Access Audit Site Report

Estero Llano Grande State Park
3301 S International Blvd
Weslaco, TX 78596
Accessibility Evaluation
Inspection Date: 07/13/2022
Inspectors: Tanya Scheibe

Prepared By
WT Group

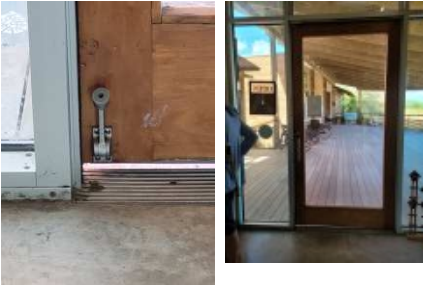
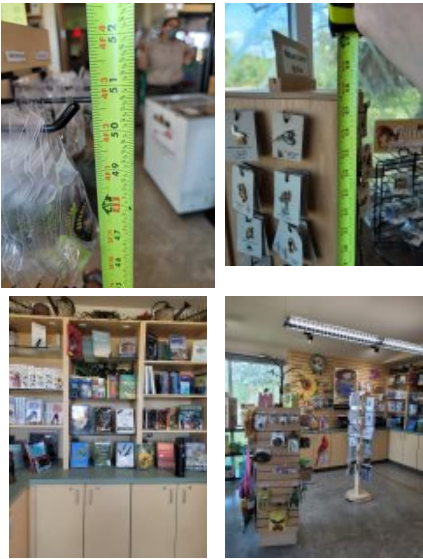
22	Headquarters Area: HQ - Exterior Accessible Route	[26.1264963 , -97.956665 8]	The landing at the bottom of the ramp has a slope greater than 2%. Bottom landings shall have a dimension in the direction of ramp run of not less than 60 inches and have a slope of less than 2% in any direction.	Ramp to HQ - 3.8% slope at top landing	Correct ramp landing slope to max 2.08%	2015 ABAAS Section: 405.7.1, 405.7.1 EXCEPTION 2012 TAS Section: 405.7.1, 405.7.1 Exception 2010 ADAS Section: 405.7.1, 405.7.1 Exception

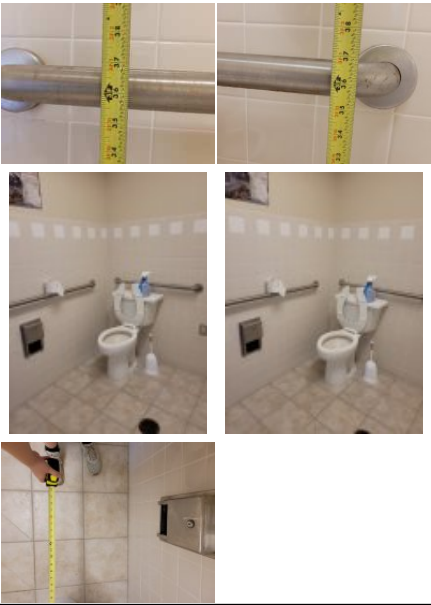
31	Headquarters Area: HQ - Women's Restroom	[26.12522, -97.95452]	Element meets all standards and requirements	door complies	None	2010 ADAS Section: N/A

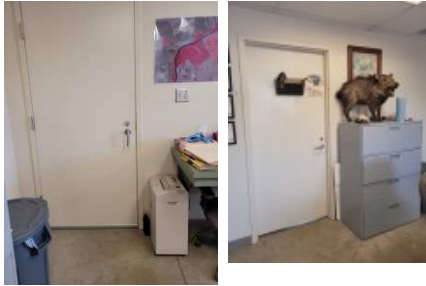
33	Headquarters Area: HQ - Public Spaces	[26.1263887 , -97.956649 7]	The operable part is positioned too high for either a side or front approach. Where a clear floor or ground space allows a parallel approach to an element and the side reach is unobstructed, the high side reach shall be 48 inches maximum and the low side reach shall be 15 inches minimum above the finish floor or ground. Where a forward reach is unobstructed, the high forward reach shall be 48 inches maximum and the low forward reach shall be 15 inches minimum above the finish floor or ground.	merchandise is 51" AFF over counter	Lower merchandise to max 44" AFF for a reach over the counter. In the alternative, train staff to be alert to patrons needing assistance.	2015 ABAAS Section: 308.1 2012 TAS Section: 308.1 2010 ADAS Section: 308.1		
34	Headquarters Area: HQ - Public Spaces	[26.1263807 , -97.956601 4]	There is not enough knee clearance under the drinking fountain. The drinking fountain must have a clear knee space between the bottom of the drinking fountain and the floor not less than 27 inches in height, 30 inches in width, and 8 inches in depth.	fountains at HQ restrooms would comply, but the accessible fountain leaks in knee and toe clearance when pressed	Correct leak at fountain to prevent water overflow	2015 ABAAS Section: 602.2 2012 TAS Section: 602.2 2010 ADAS Section: 602.2

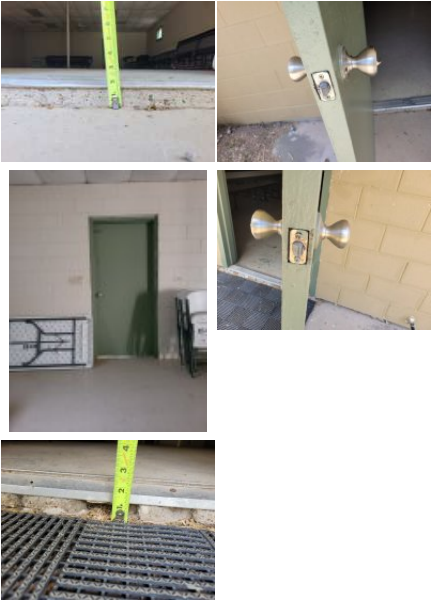
Finding Number	Area Description	Lat/Long	Finding	As Built	Recommendation	Citation	Photos	Figure
70	Park Site: Indigo Blind	[26.1236354 , -97.9581249]	The ramp on the accessible route contains cross slopes greater than 2%. Surface cross slopes shall not exceed one unit vertical in 48 units horizontal (2-percent slope).	entry ramp - cross slopes - 3.2%, 3%	Correct ramp cross slope to max 2.08%	2015 ABAAS Section: 405.3 2012 TAS Section: 405.3 2010 ADAS Section: 405.3		
71	Park Site: Indigo Blind	[26.1236643 , -97.9580981]	The landing at the bottom of the ramp has a slope greater than 2%. Bottom landings shall have a dimension in the direction of ramp run of not less than 60 inches and have a slope of less than 2% in any direction.	Entry ramp - Lacks bottom landing, CIL at landing	Provide a ramp landing with firm and stable surface and slope to max 2.08%	2015 ABAAS Section: 405.7.1, 405.7.1 EXCEPTION 2012 TAS Section: 405.7.1, 405.7.1 Exception 2010 ADAS Section: 405.7.1, 405.7.1 Exception

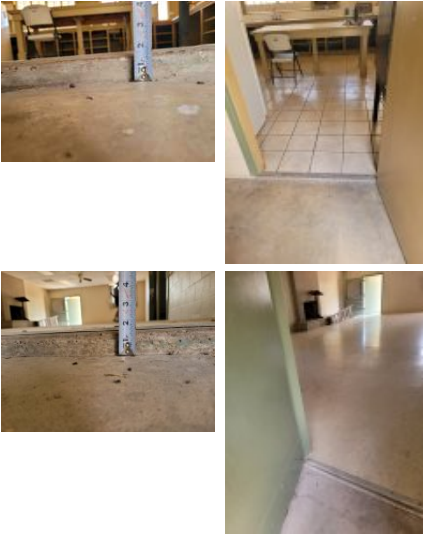
Finding Number	Area Description	Lat/Long	Finding	As Built	Recommendation	Citation	Photos	Figure
85	Camp Thicket Group Area: North Complex - Public Spaces	[26.124223, -97.961048 5]	The restroom sign does not comply with one or more applicable requirements for the location, height, and properties of the sign.	Cha Cha Restroom - sign on door, lacks Braille, raised characters, and International Symbol of Accessibility	Replace sign with one of contrasting colors that includes Braille, raised characters, and the symbol of accessibility and mount on the wall, latch side of the door, 48" to the baseline of the lowest character and 60" to the baseline of the highest character.	2015 ABAAS Section: F216.2, 703.1, 703.2, 703.5, 703.6 2012 TAS Section: 216.2, 703.1, 703.2, 703.5, 703.6 2010 ADAS Section: 216.2, 703.1, 703.2, 703.5, 703.6		
86	Camp Thicket Group Area: North Complex - Public Spaces	[26.1240833, -97.961043 1]	The mirror is mounted too high. Mirrors must have the bottom edge of the reflecting surface a maximum of 40 inches above the floor if above a sink or counter. Mirrors not located above lavatories or countertops shall be installed with the bottom edge of the reflecting surface 35 inches maximum above the finish floor or ground.	Cha Cha Restroom - bottom of mirror 48.5" AFF, top of mirror 66" AFF	Replace mirror so bottom reflective surface is max 40" AFF and 74" at the top.	2015 ABAAS Section: 603.3 2012 TAS Section: 603.3 2010 ADAS Section: 603.3

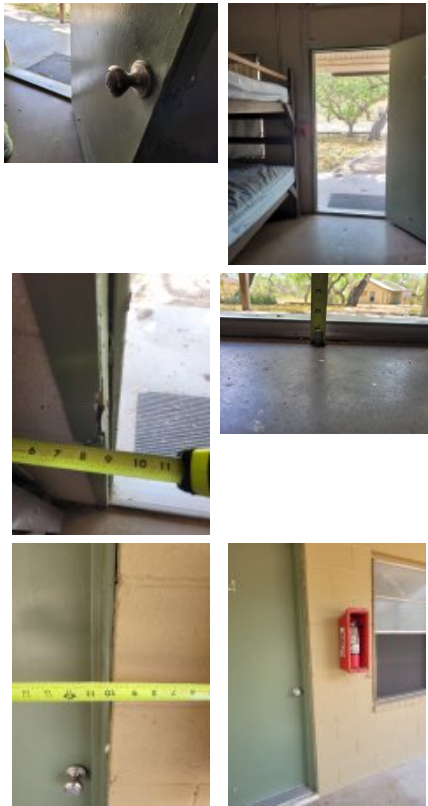
Finding Number	Area Description	Lat/Long	Finding	As Built	Recommendation	Citation	Photos	Figure
89	Camp Thicket Group Area: North Complex - Public Spaces	[26.1241989 , -97.961032 4]	The side grab bars are not in the correct location. Grab bars on the side wall must be installed so that the end closest to the rear wall is maximum 12" from the rear wall. The end furthest from the rear wall must be mounted minimum 54" from the rear wall.	Cha Cha Restroom - 36" grab bar mounted 10.5" from wall, extends 45.5" to grab bar end	Replace side grab bar with a 42" long bar mounted to max 12" from the rear wall at the close end and min 54" on the far end, and 33" to 36" aff.	2015 ABAAS Section: 604.5.1 2012 TAS Section: 604.5.1 2010 ADAS Section: 604.5.1		
90	Camp Thicket Group Area: North Complex - Public Spaces	[26.1241893 , -97.961021 7]	The rear grab bar is not 36" long or is not mounted in the correct location. The rear grab bar must be a minimum of 36" long and extend from the toilet centerline a minimum 12" towards the wall side and a minimum 24" towards the open side of the toilet. Grab bars shall be installed in a horizontal position, 33 inches minimum and 36 inches maximum above the finish floor measured to the top of the gripping surface and the space between the grab bar and the top of the tank shall be 1-1/2 inches minimum.	Cha Cha Restroom - 24" grab bar, 4" centerline from closed side	Replace rear grab bar with one 36" long, mounted behind the toilet, 12" to the wall side of center and 24" to the open side and 33" to 36" AFF.	2015 ABAAS Section: 604.5.2 2012 TAS Section: 604.5.2 2010 ADAS Section: 604.5.2

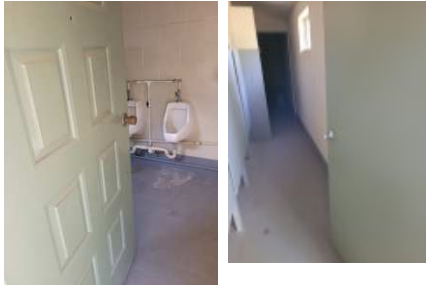
Finding Number	Area Description	Lat/Long	Finding	As Built	Recommendation	Citation	Photos	Figure
99	Camp Thicket Group Area: North Complex - Public Spaces	[26.1242086 , -97.961086]	The controls are located such that operation require reaching across burners. Where knee and toe space is provided, the underside of the range or cooktop shall be insulated or otherwise configured to prevent burns, abrasions, or electrical shock. The location of controls shall not require reaching across burners	Cha Cha Kitchen - oven controls on back	Replace oven with one having controls on the front panel	2015 ABAAS Section: 804.6.4 2012 TAS Section: 804.6.4 2010 ADAS Section: 804.6.4		
100	Camp Thicket Group Area: North Complex - Public Spaces	[26.1242459 , -97.9610546]	The threshold at a doorway shall be no higher than 1/2 inch. Changes in level between 1/4 inch and 1/2 inch must be beveled at 1:2 or less. 1/4 inch is the maximum vertical rise. Hand-activated door opening hardware, handles, pulls, latches, locks, and other operating devices on accessible doors shall have a shape that is easy to grasp with one hand and does not require tight grasping, tight pinching or twisting of the wrist to operate. Hardware shall be 34 inches minimum and 48 inches maximum above the finish floor or ground.	Cha Cha Kitchen - 2 doors to kitchen - knobs, 1.75 change in level into kitchen, 1.75" change in level into group hall	For all doors along the public circulation route, repair, bevel, or ramp CILs at door entries to max .25". For all doors along the public circulation route, replace hardware with lever hardware or hardware operable without a tight pinch or grasp.	2010 ADAS Section: 404.2.3, 404.2.7, 404.2.4, 404.2.11, 404.2.11 Exception

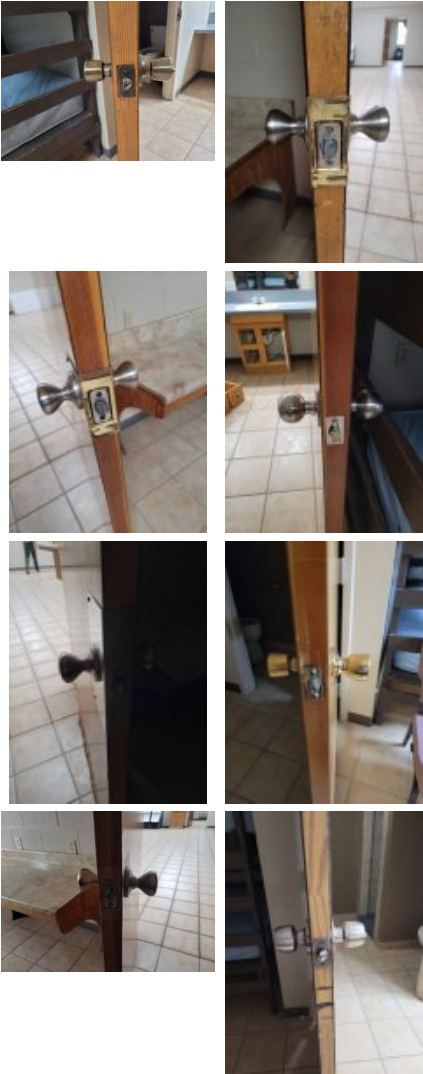
111	Camp Thicket Group Area: North Complex - Men's Restroom	[26.1242471 , -97.960163 4]	The stall door fails to comply with all of the door requirements. The stall door must be a minimum of 32" wide and have compliant hardware on both sides. The stall door must be self-closing.	Chapel Men's Restroom - stall door lacks push hardware, not self closing	Adjust stall door to be self-closing. Replace stall hardware with hardware operable without a tight pinch or grasp on both sides of the stall door.	2015 ABAAS Section: 404.2.3, 404.2.7, 604.8.2.2 2012 TAS Section: 404.2.3, 404.2.7, 604.8.2.2 2010 ADAS Section: 404.2.3, 404.2.7, 604.8.2.2

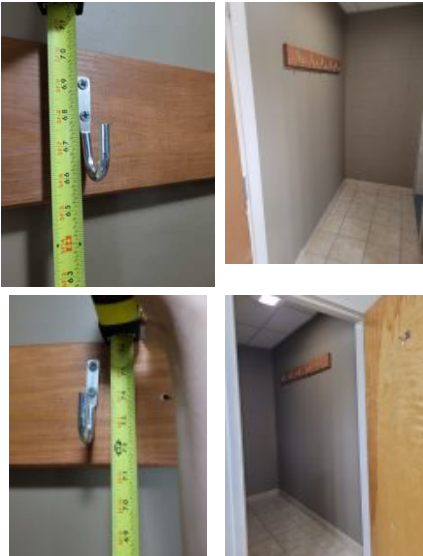
Finding Number	Area Description	Lat/Long	Finding	As Built	Recommendation	Citation	Photos	Figure
125	Camp Thicket Group Area: South Complex - Public Spaces	[26.1229756 , -97.9603458]	The door operating hardware is not accessible. Hand-activated door opening hardware, handles, pulls, latches, locks, and other operating devices on accessible doors shall have a shape that is easy to grasp with one hand and does not require tight grasping, tight pinching or twisting of the wrist to operate. Hardware shall be 34 inches minimum and 48 inches maximum above the finish floor or ground.	The nest, rooms 1-4 - 8 knobs total	Replace hardware with lever hardware or hardware operable without a tight pinch or grasp	2015 ABAAS Section: 404.2.7 2012 TAS Section: 404.2.7 2010 ADAS Section: 404.2.7		 <p>Operating hardware must be centered between 34" and 48" above the floor or ground</p>

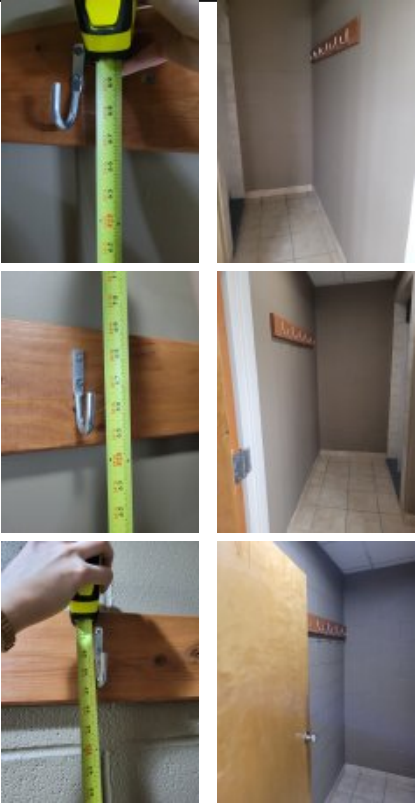
Finding Number	Area Description	Lat/Long	Finding	As Built	Recommendation	Citation	Photos	Figure
126	Camp Thicket Group Area: South Complex - Public Spaces	[26.1229756 , -97.9603028]	The operable part is positioned too high for either a side or front approach. Where a clear floor or ground space allows a parallel approach to an element and the side reach is unobstructed, the high side reach shall be 48 inches maximum and the low side reach shall be 15 inches minimum above the finish floor or ground. Where a forward reach is unobstructed, the high forward reach shall be 48 inches maximum and the low forward reach shall be 15 inches minimum above the finish floor or ground.	The nest for rooms 1-5 - shelf and rod - rod at 66" AFF, shelf 69" (5 instances of this), 5 - light 56" AFF	Remount operable parts to be in reach range of 15" min to 48" max. in at least one room.	2015 ABAAS Section: 308.1 2012 TAS Section: 308.1 2010 ADAS Section: 308.1

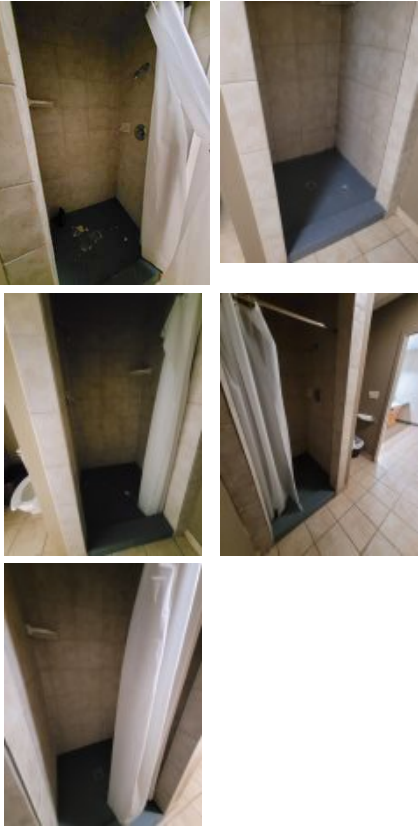
Finding Number	Area Description	Lat/Long	Finding	As Built	Recommendation	Citation	Photos	Figure
127	Camp Thicket Group Area: South Complex - Public Spaces	[26.1229852 , -97.9603136]	The top of the work surface is not within a compliant height range. The tops of tables and counters shall be 28 inches to 34 inches from the floor or ground.	The nest, in rooms 1-5 (5 total) vanity has 24" knee	Provide tables and work surfaces at 28" to 34" aff with required knee and toe clearances in at least one room.	2015 ABAAS Section: 902.3 2012 TAS Section: 902.3 2010 ADAS Section: 902.3

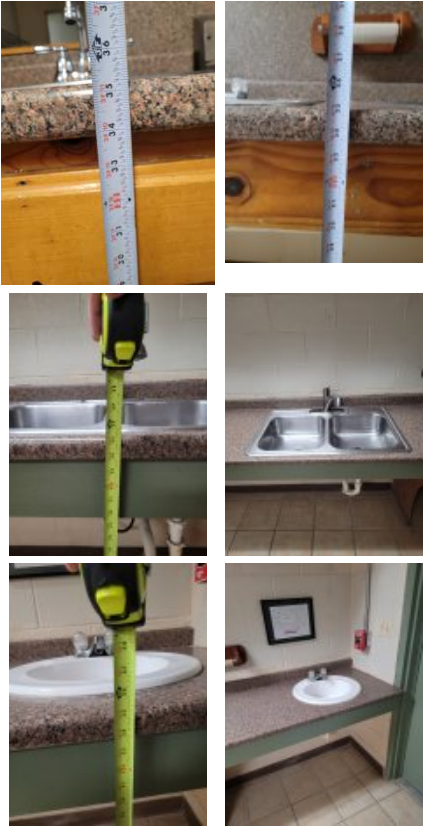
Finding Number	Area Description	Lat/Long	Finding	As Built	Recommendation	Citation	Photos	Figure
133	Camp Thicket Group Area: South Complex - Public Spaces	[26.1230093 , -97.960327]	There are no accessible bathing or shower facilities. Where facilities for bathing are provided for the public, clients or employees, including showers or bathtubs, at least one shower or bathtub and support facilities such as lockers, and not less than 1 percent of all facilities, shall be accessible.	The nest, restrooms 1-5 - 1-5 rooms all have non accessible showers (5 total)	Create an accessible shower in at least one bathing room	2015 ABAAS Section: F213.3.6 2012 TAS Section: 213.3.6 2010 ADAS Section: 213.3.6

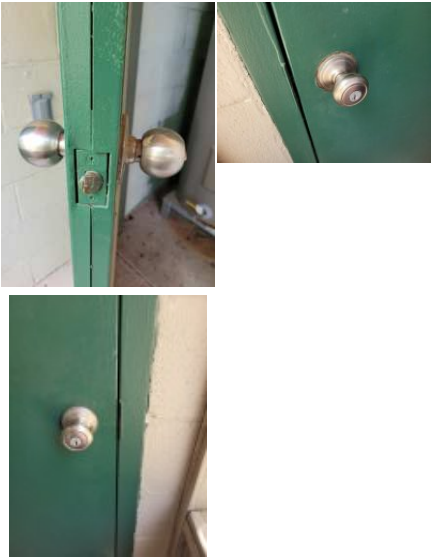
Finding Number	Area Description	Lat/Long	Finding	As Built	Recommendation	Citation	Photos	Figure
135	Camp Thicket Group Area: South Complex - Public Spaces	[26.1229756 , -97.960292 1]	Thresholds, if provided at doorways, shall be 1/2 inch (13 mm) high maximum. Raised thresholds and changes in level at doorways shall comply with 302 and 303. Changes in level of ¼ inch (6.4 mm) high maximum shall be permitted to be vertical. Changes in level between ¼ inch (6.4 mm) high minimum and ½ inch (13 mm) high maximum shall be beveled with a slope not steeper than 1:2. Changes in level greater than ½ inch (13 mm) high shall be ramped, and shall comply with 405 or 406.	The Nest - 2" change in level on breezeway door	Repair, bevel or ramp CIL at doorway	2015 ABAAS Section: 303.3, 404.2.5, 303.2, 303.4 2012 TAS Section: 303.3, 404.2.5, 303.2, 303.4 2010 ADAS Section: 303.3, 404.2.5, 303.2, 303.4		
136	Camp Thicket Group Area: South Complex - Public Spaces	[26.1229659 , -97.960324 3]	An item or items project more than 4 inches into the circulation path. Wall-mounted objects that have leading edges between 27 inches and 80 inches from the floor must not project more than 4 inches into the circulation path. Protruding objects that extend to the floor or within 27 inches of the floor are cane detectable and are therefore not hazardous. Where it is necessary or desirable to have objects protrude from the wall, a manner of cane detection must be provided.	The Nest - 2 of 2 kitchen service counters project 5.25"	Relocate protruding objects or place cane detectable warning or bollard at foot of item.	2015 ABAAS Section: 307.2 2012 TAS Section: 307.2 2010 ADAS Section: 307.2

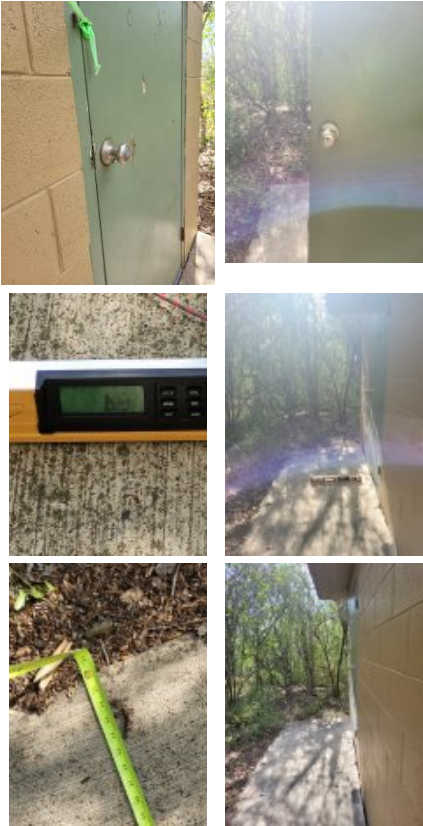
Finding Number	Area Description	Lat/Long	Finding	As Built	Recommendation	Citation	Photos	Figure
152	Camp Thicket Group Area: South Complex - Women's Restroom	[26.1230045 , -97.960313 6]	The restroom sign does not comply with one or more applicable requirements for the location, height, and properties of the sign.	The Nest - lacks compliant signage	Acquire and mount signage, including Braille and raised lettering and mount on wall, latch side of door, 48" to baseline of lowest character and 60" to baseline of highest character.	2015 ABAAS Section: F216.2, 703.1, 703.2, 703.5, 703.6 2012 TAS Section: 216.2, 703.1, 703.2, 703.5, 703.6 2010 ADAS Section: 216.2, 703.1, 703.2, 703.5, 703.6		
153	Camp Thicket Group Area: South Complex - Women's Restroom	[26.1229733 , -97.960301 9]	Door openings shall provide a clear width of 32 inches (815 mm) minimum. Clear openings of doorways with swinging doors shall be measured between the face of the door and the stop, with the door open 90 degrees. Openings more than 24 inches (610 mm) deep shall provide a clear opening of 36 inches (915 mm) minimum. There shall be no projections into the required clear opening width lower than 34 inches (865 mm) above the finish floor or ground. Projections into the clear opening width between 34 inches (865 mm) and 80 inches (2030 mm) above the finish floor or ground shall not exceed 4 inches (100 mm). Hand-activated door opening hardware, handles, pulls, latches, locks, and other operating devices on accessible doors shall have a shape that is easy to grasp with one hand and does not require tight grasping, tight pinching or twisting of the wrist to operate. Hardware shall be 34 inches minimum and 48 inches maximum above the finish floor or ground.	The Nest - 21" width, knob	For all doors along the public circulation route, replace doors with doors having 80" overhead clearance and 32" clear width. For all doors along the public circulation route, replace hardware with lever hardware or hardware operable without a tight pinch or grasp.	2010 ADAS Section: 404.2.3, 404.2.7, 404.2.4, 404.2.11, 404.2.11 Exception

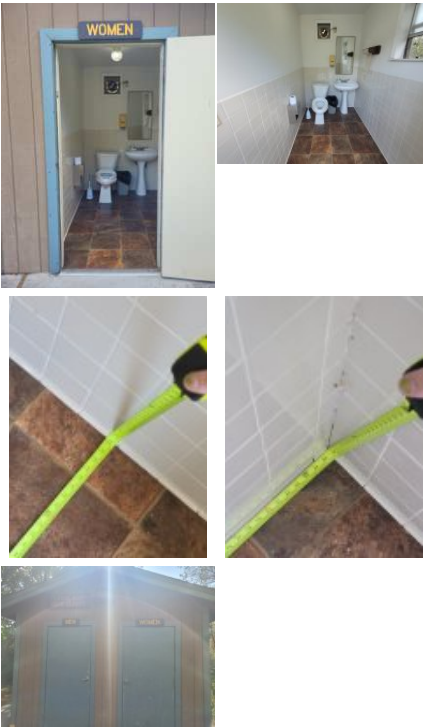
159	Pauraque Event Center: Pauraque - Public Spaces	[26.1234668 , -97.957491 9]	The controls are located such that operation require reaching across burners. Where knee and toe space is provided, the underside of the range or cooktop shall be insulated or otherwise configured to prevent burns, abrasions, or electrical shock. The location of controls shall not require reaching across burners	Event Center Kitchen - controls on back	Replace oven with one having controls on the front panel	2015 ABAAS Section: 804.6.4 2012 TAS Section: 804.6.4 2010 ADAS Section: 804.6.4		
160	Pauraque Event Center: Pauraque - Public Spaces	[26.1234476 , -97.957524 1]	Element meets all standards and requirements	door to kitchen complies	None	2010 ADAS Section: N/A

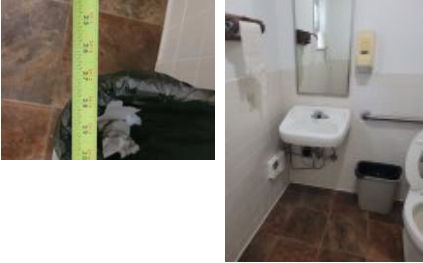
165	Pauraque Event Center: Pauraque - Men's Restroom	[26.123462, -97.9575026]	The restroom is not compliant. The restroom does not have the required minimum clear floor space or maneuvering clearances for the toilet. The restroom does not have the required minimum clear floor space or maneuvering clearances for the lavatory. The entry door does not contain the required minimum maneuvering spaces on the pull/push sides. The entry door encroach into the required clear floor space for fixtures. Grab bars are missing and/or incorrectly installed. Accessories, such as toilet seat covers, paper towel holders, garbage cans, hand dryers, and mirrors are either too high or without clear floor space or both.	no accessible features; shower not accessible	Create a compliant wheelchair accessible restroom and correct all features to be accessible if feasible.	2015 ABAAS Section: 603.1 2012 TAS Section: 603.1 2010 ADAS Section: 603.1

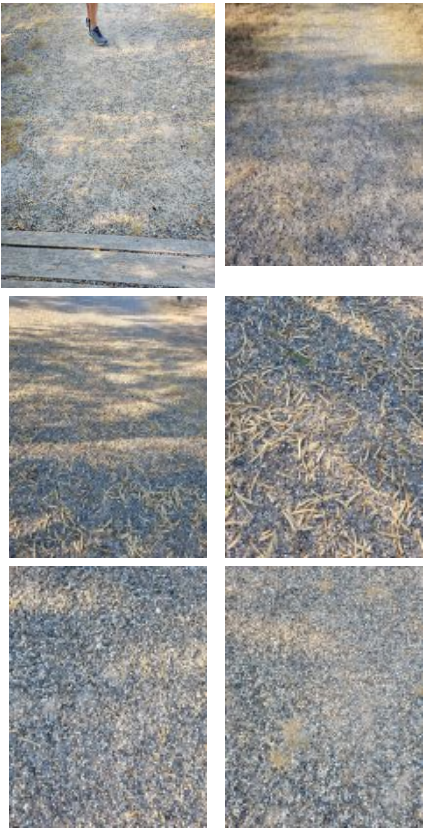
Finding Number	Area Description	Lat/Long	Finding	As Built	Recommendation	Citation	Photos	Figure
170	Pauraque Event Center: Bird Bath Restroom - Womens	[26.123409, -97.957567]	Minimum maneuvering clearances at doors and gates shall comply with 404.2.4. Maneuvering clearances shall extend the full width of the doorway and the required latch side or hinge side clearance.	Door - 5" clearance on push	Provide required maneuvering clearance on push side of door	2015 ABAAS Section: 404.2.4.4, 404.2.4.1 2012 TAS Section: 404.2.4.4, 404.2.4.1 2010 ADAS Section: 404.2.4.4, 404.2.4.1		
171	Pauraque Event Center: Bird Bath Restroom - Womens	[26.1234283, -97.9574812]	50% of the single accommodation restrooms provided in this grouping are not nearly compliant. The restrooms do not have the required minimum clear floor space or maneuvering clearances for the toilet, The restrooms do not have the required minimum clear floor space or maneuvering clearances for the lavatory, The entry doors do not contain the required minimum maneuvering spaces on the pull/push sides, The entry doors encroach into the required clear floor space for fixtures, Grab bars are missing and/or incorrectly installed, Accessories, such as toilet seat covers, paper towel holders, garbage cans, hand dryers, and mirrors are either too high or without clear floor space or both, The restrooms contain floor level changes greater than a 1/2 inch, the showers are too small and missing numerous accessible elements.	non compliant restroom - women's 56 x 86.5", lacks directional signage	Create compliant wheelchair accessible restrooms and correct all features to be accessible if feasible to meet 50% compliant restrooms in this location.	2015 ABAAS Section: 603.1 2012 TAS Section: 603.1 2010 ADAS Section: 603.1
